# Rye Park *Wind Farm*

Response to Submissions

12 May 2016

Application No SSD 6693

Figure 3-2 A comparison of the previously exhibited project layout and the revised layout

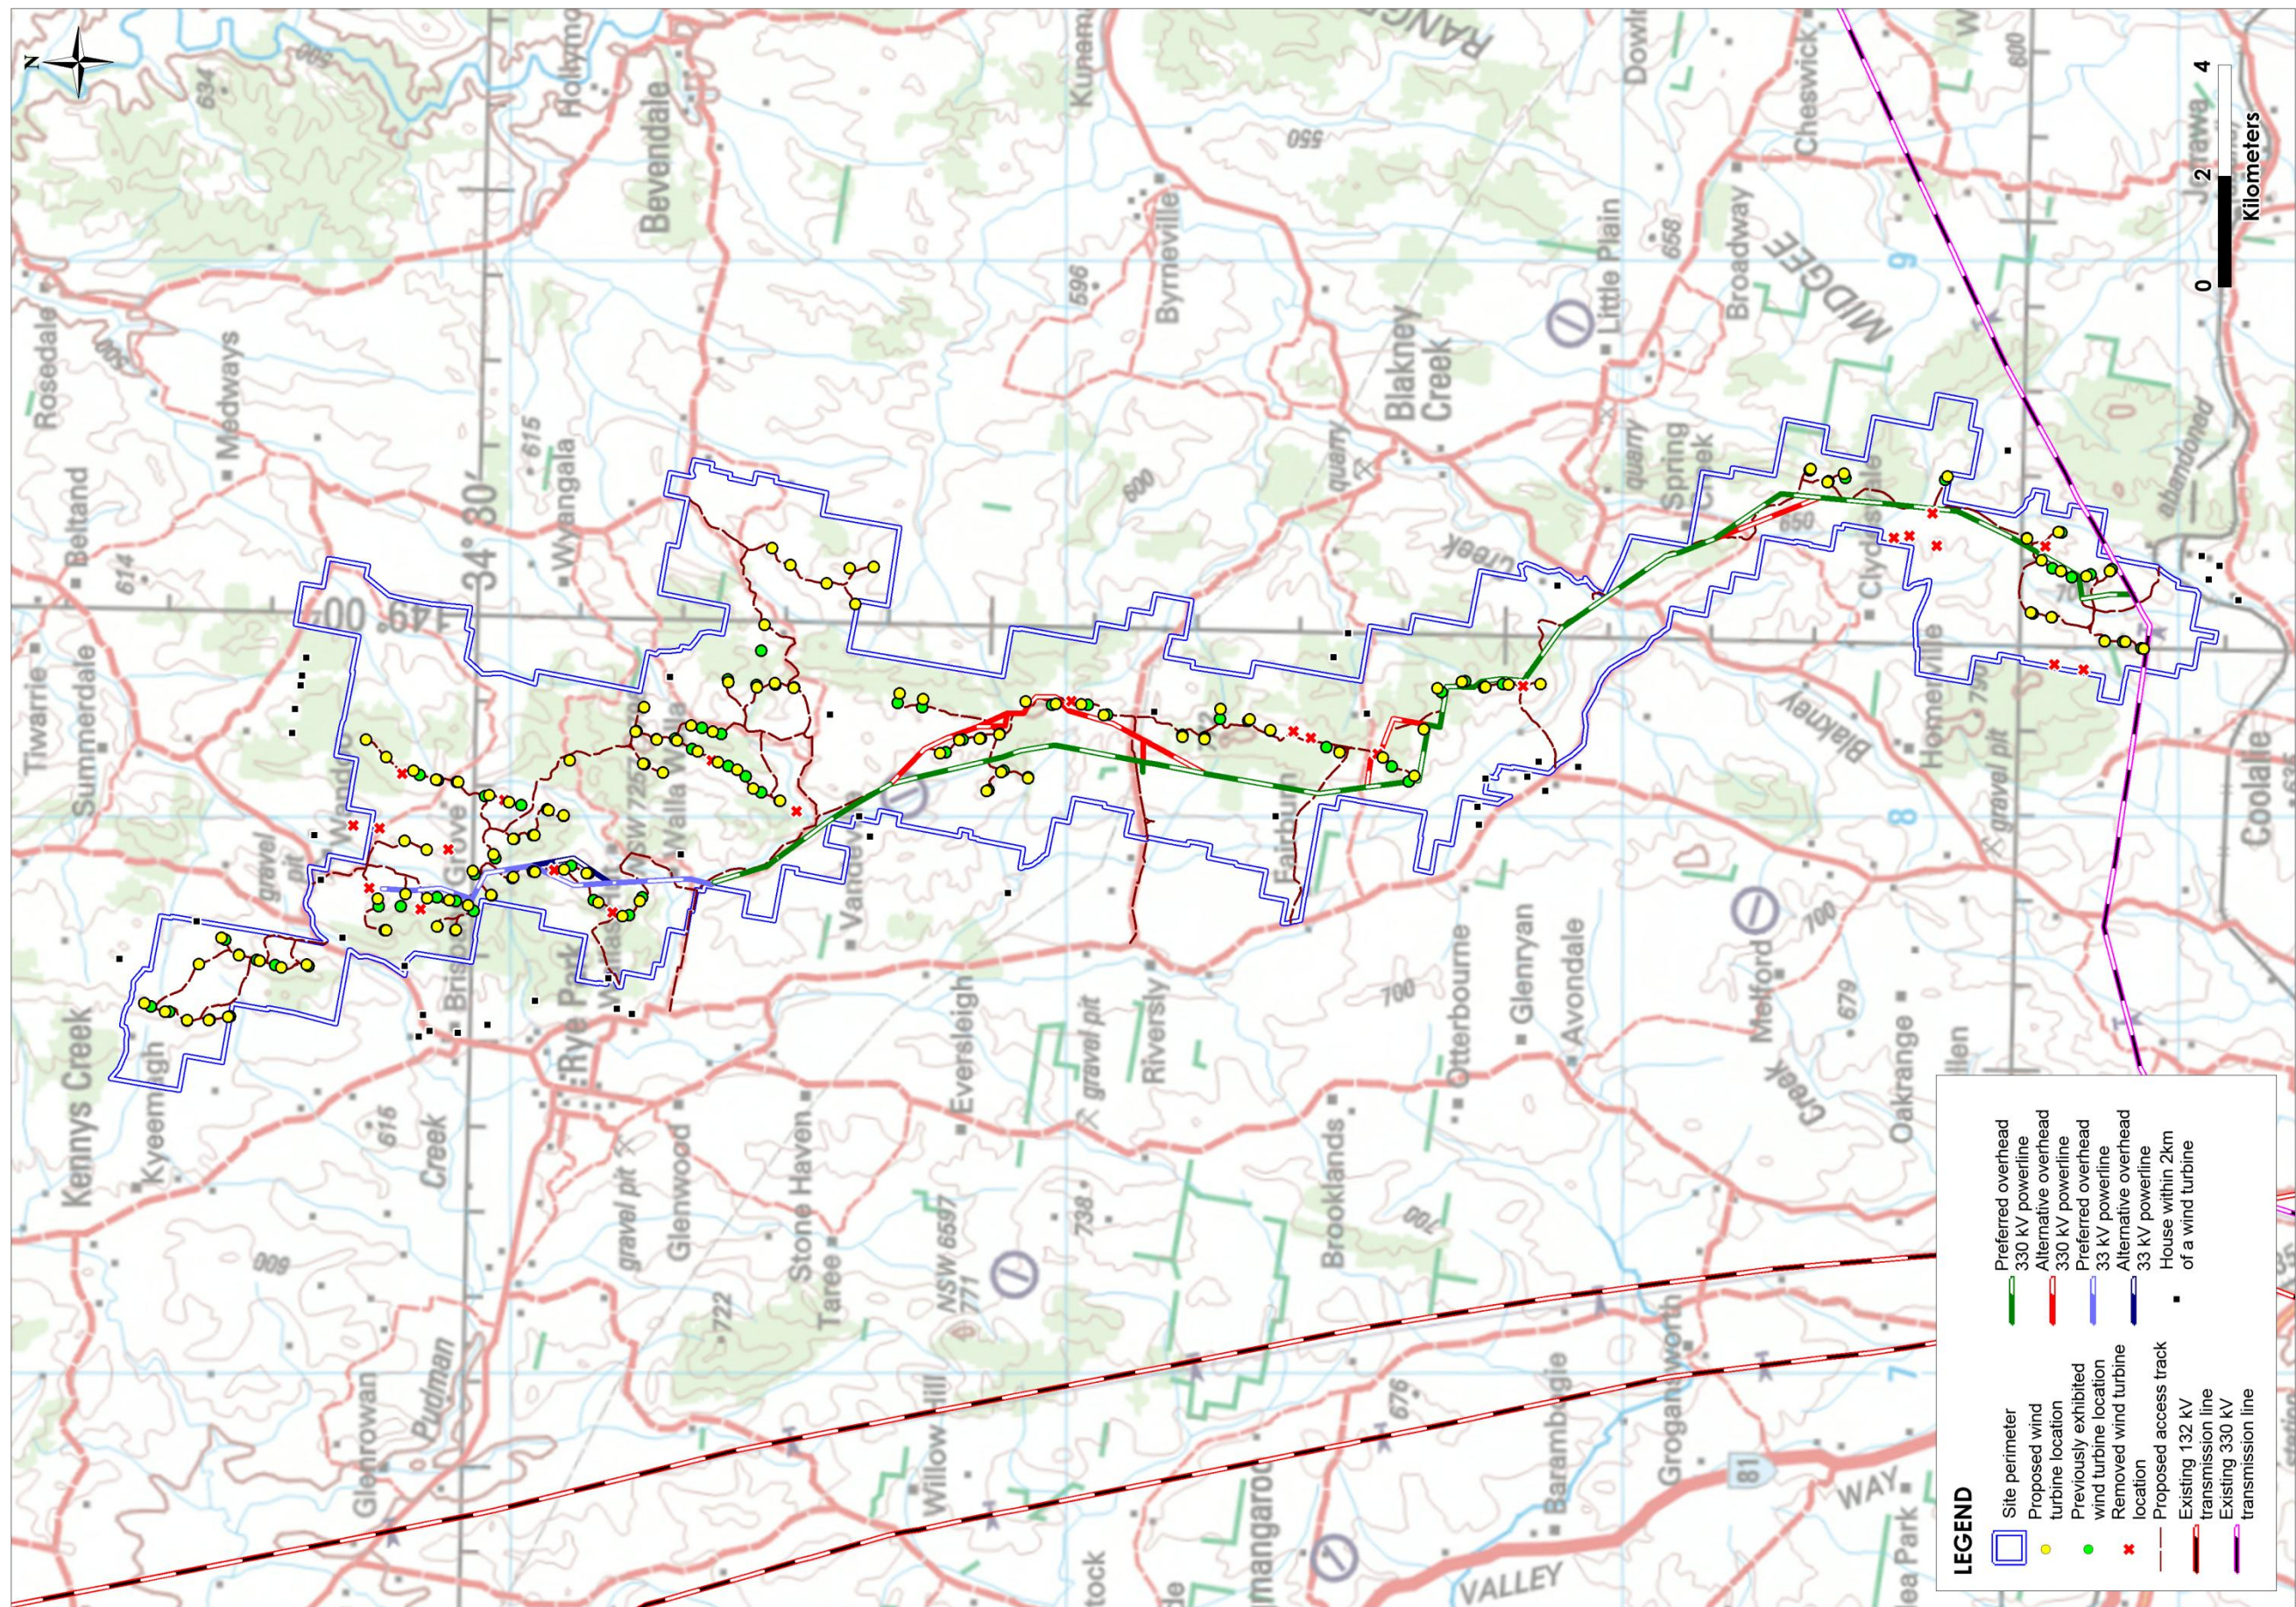
Figure 3-2 shows a comparison of the indicative layout contained in the EA and the revised layout for the project.

| Item No. | Comment  |
|----------|--|
| 8        | Alternate location for Collection substation 1 identified (refer Figure 3-17)          |

Figure 3-4 Example of changes made to transmission line and turbine location

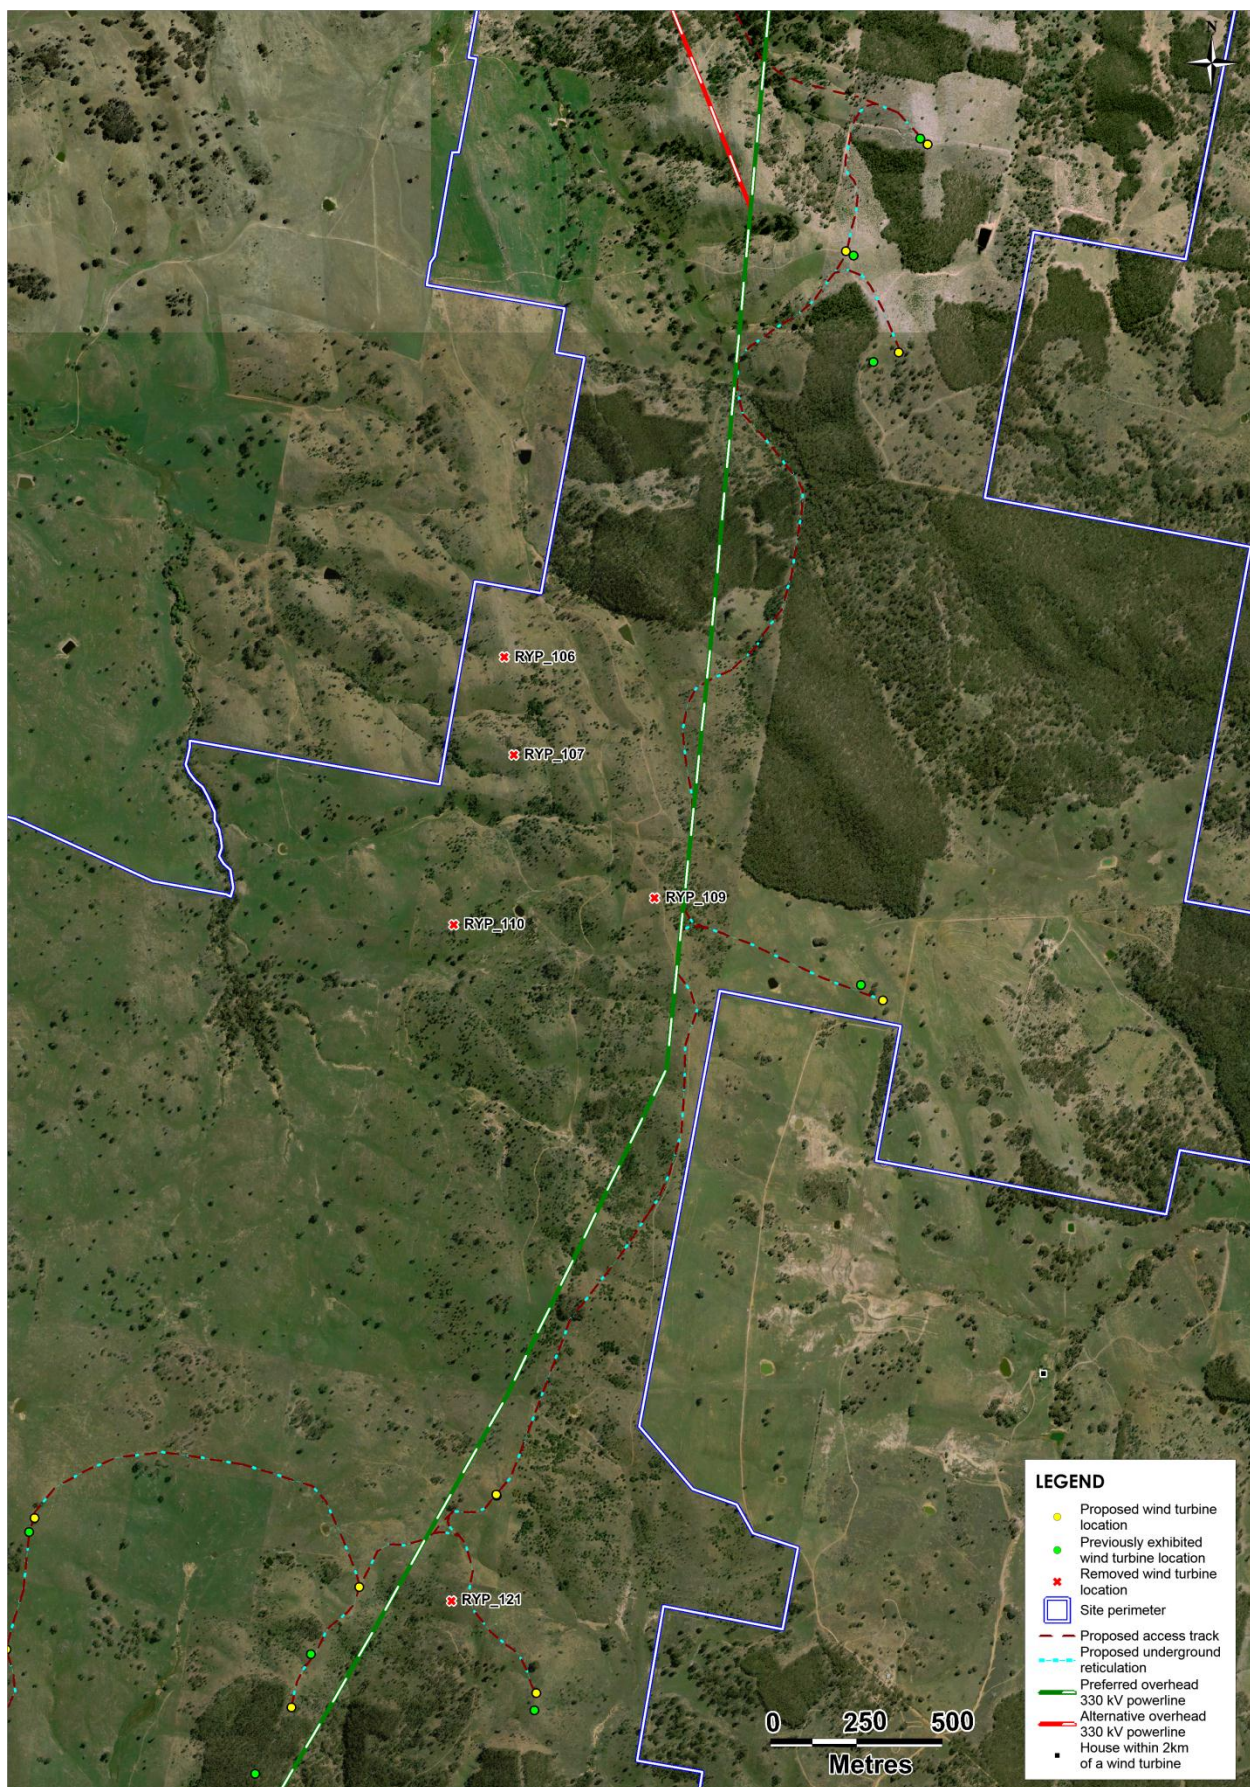
| Item No. | Comment   |
|----------|---|
| 3        | New 330 kV alternative line added east of turbine 77. This route is more direct and avoids woodland vegetation        |

Figure 7-2 Current Mineral Exploration Licenses across the project site

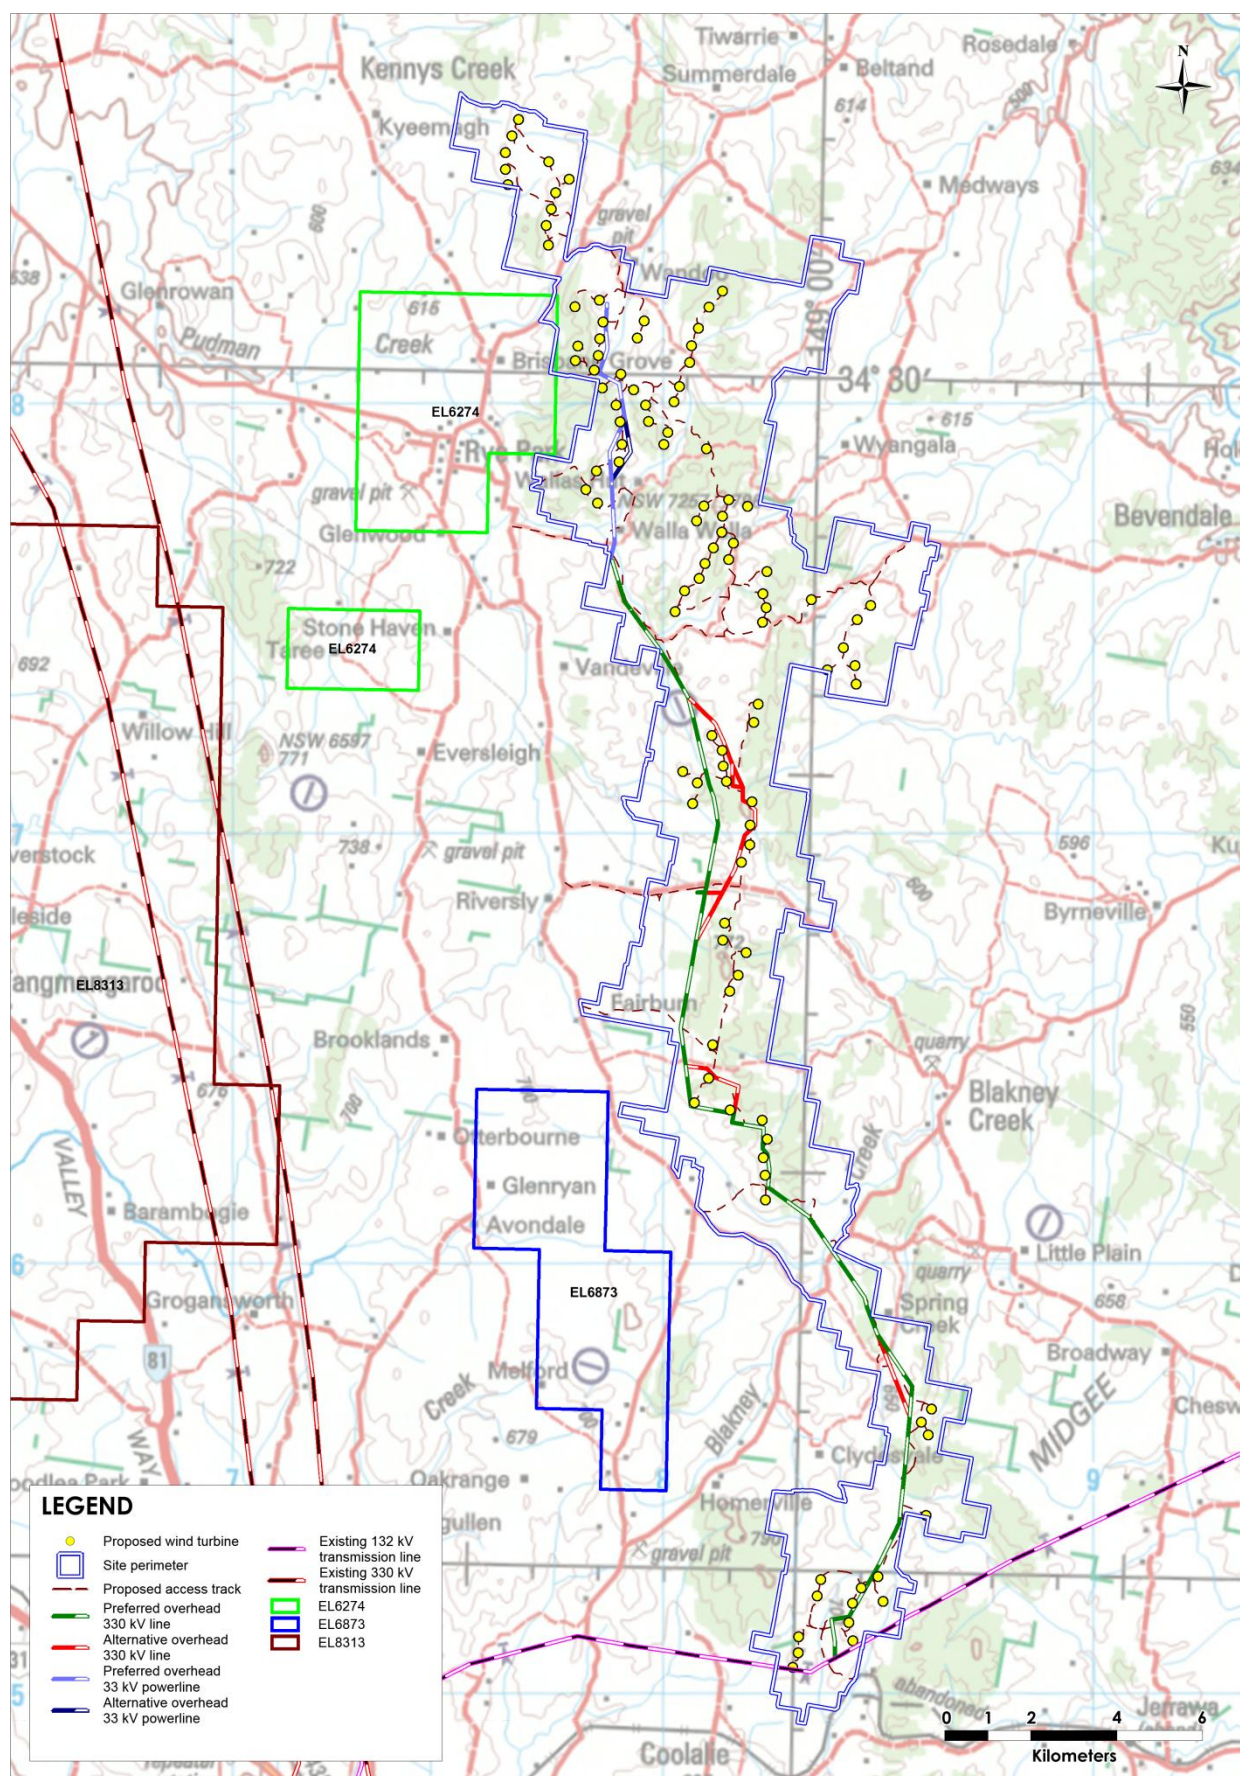
| Comments   | Response   |
|--|--|
| The Proponent is encouraged to continue to liaise with holders of mineral exploration licenses to ensure that no potentially prospective areas will be compromised by the project. | Refer updated map in section Figure 7-2 which shows the location of current mineral exploration licence areas relative to the wind farm. Details of current correspondence with the mineral licence holders are also listed. |
